Site: Kiddie Academy – C12E004
4590 Paradise Blvd NW

Re: Drainage Ordinance (14-5-2-1) Violations

Aug 21, 2020 7:35:04 AM
4588 Paradise Boulevard Northwest
Albuquerque
Bernalillo County
New Mexico

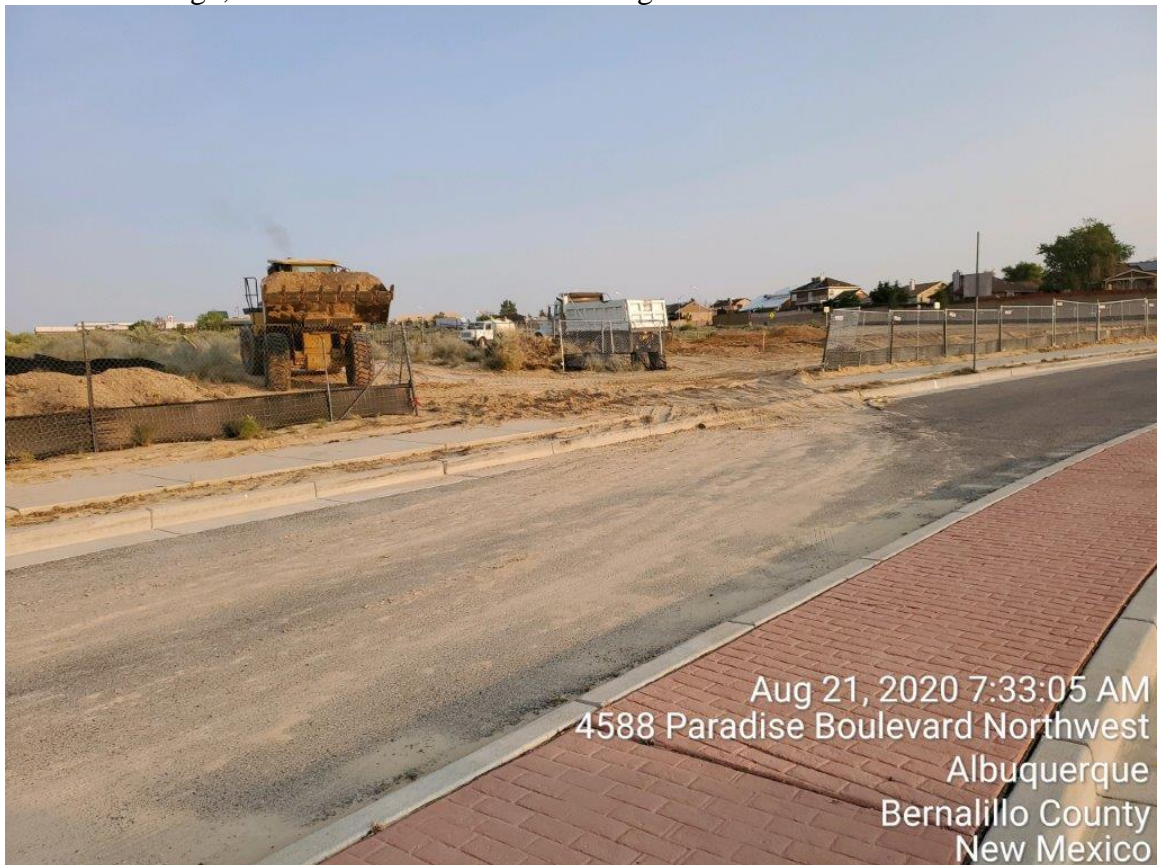
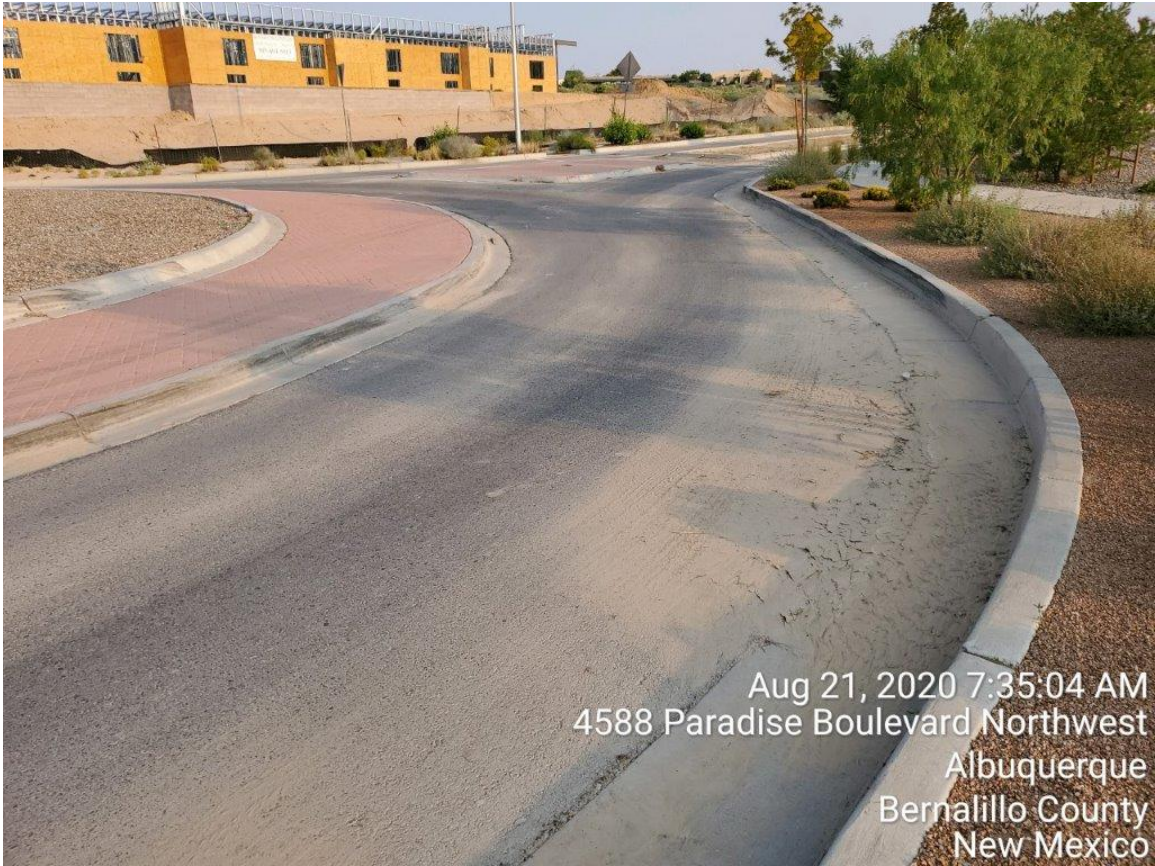
1. The Construction entrance was still missing after the violation was reported a week ago, and trackout has remained and grown worse for a week.

1. Construct missing BMPs (Construction Entrance) and maintain them
2. Where sediment has been tracked-out from your site onto paved roads and sidewalks remove the deposited sediment by the end of the same business day in which the track-out occurs per CGP 2.2.4.d.
